Service description

Product: SP200	Service description no: 3112-S013	Ver: 2
-------------------	---	-----------

Figure 1

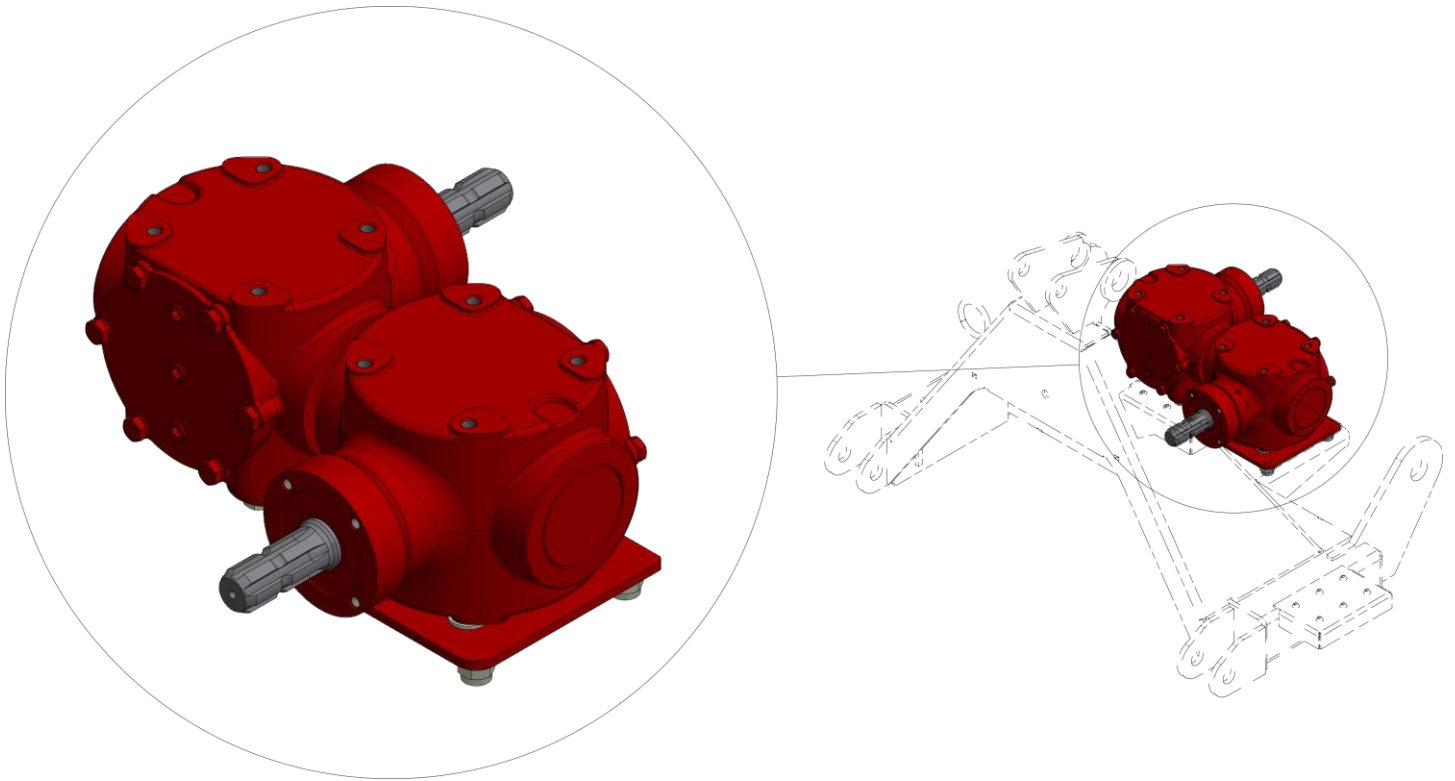
The double gearbox replacement. The new gearbox does not fit.

The hole pattern in the new gearbox does not match the hole pattern on the tractor attachment.

Follow the instructions below before the replacement to a new gearbox.

The plate (position 7) is an adapter plate to adapt the hole pattern on the new gearbox to the hole pattern on the pump mount.
